Interactive comment on “The seamless and multi-model coupling between atmosphere, land, hydrology, ocean, waves and sea-ice models based on SURFEX surface model using OASIS3-MCT” by Aurore Voldoire et al.

Aurore Voldoire et al.

Received and published: 28 July 2017

Fig. 1.

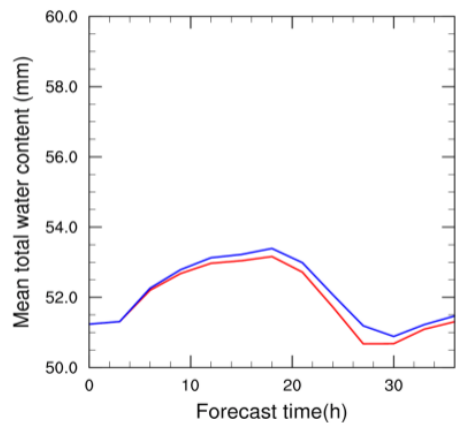
RC: Concerning the MESONH-NEMO section, the illustration of the coupling effect on the tropical cyclone structure is not clear (and the units are missing). A better illustration would be to present the time evolution of the cyclone intensity or the water content averaged over the domain region.

AA: The evolution of the domain-averaged integrated water content is shown in Figure 1 (below, in this document) for the MESONH-NEMO model over the Indian Ocean. It shows that in the CPL run, there is systematically slightly more water than in the NOCPL run, but it does not show the impact on the structure of the system, and especially on the position and intensity of the eyewall represented by the region of maximum values of total water, which is what we want to illustrate. So, to render Figure 7 (old Fig. 8) more readable and in order also to enlarge the size of each plot, we have decreased the number of panels shown from 6 to 4. Only the 18 h and 30 h forecast ranges have been retained. The units are also shown on Figure 7.

Figure A: Domain-averaged total water content (mm) for the NOCPL run (in red) and for the CPL run (in blue).
